Vauxhall / Opel flywheel modification

Part Number: 821303, 834018, 828019, 834243

For Vehicle: Opel / Vauxhall Astra G/H, Combo, Corsa C, Meriva, Signum, Vectra C, Zafira B
Applicable Engines: Z16XEP, Z16YNG, Z18XE, Z18XER

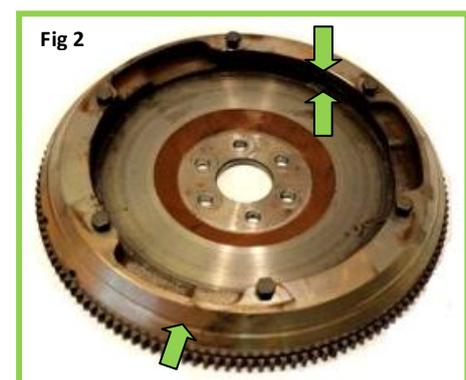
It has come to the attention of Valeo Service that the original clutch and flywheel fitted to the above vehicles experienced issues of grabbing when the vehicle was used in certain conditions. From May 2007 a modified clutch (828019/834243) and flywheel was fitted as standard to eradicate the issue. The friction material on the clutch cover was manufactured thicker than the previous clutch (821303/834018) and therefore the flywheel depth was also modified from 19mm to 21.6mm.

- 1) Check the depth of the flywheel as per Fig 1 and Fig 2
- 2) If pre 05/2007 check if the vehicle has been retro-fitted with the later clutch and flywheel. This is indicated by a Green paint mark on the gearbox (Fig 3).

Original Flywheel OE number 90536140 / 616169 without indentation and a depth of 19mm

New Flywheel OE number 93186460 / 5616016 with indentation and a depth of 21.6mm
